**2022 SMP Package IV (Nevada St) Project
Solicitation Number: CO-00471
Job No.: 21-5012 & 21-5514**

**ADDENDUM 1
September 28, 2021**

NEVADA ST. ENLARGED WATER PLAN A

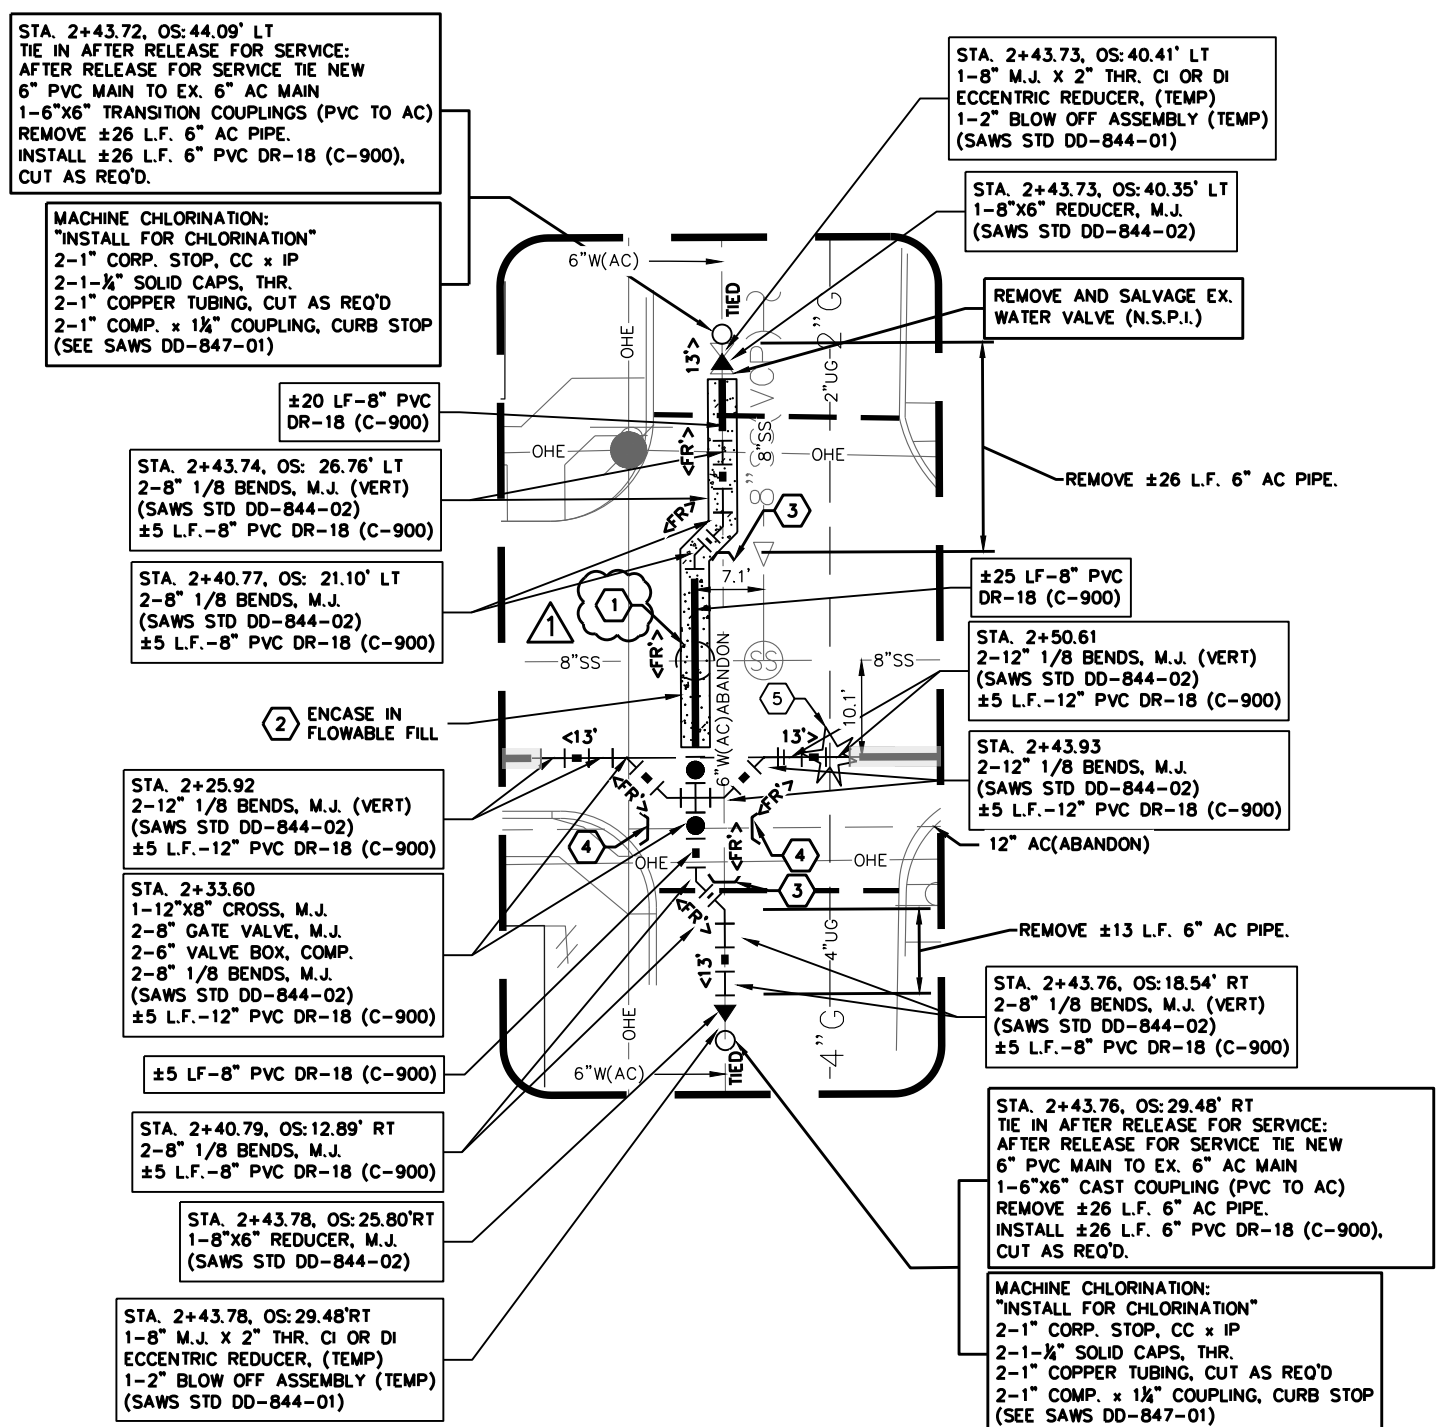
5. *Remove and replace the Bid Proposal with the attached Bid Proposal with updated section for the Statement on President's Executive Orders.*
6. *Remove Supplemental Condition to Article VIII – Contract Completion Time (Page SS-4 of the Supplemental Conditions) and replace with the attached Supplemental Condition to Article VIII – Contract Completion Time (Page SS-4 of the Supplemental Conditions) in its entirety.*
7. *Remove and replace Page W11 to the water plans with the page dated 9/21/2021 as Key Note 1 has been updated.*
8. *Remove and replace Page W13 to the water plans with the page dated 9/21/2021 as Key Note 1 has been updated.*
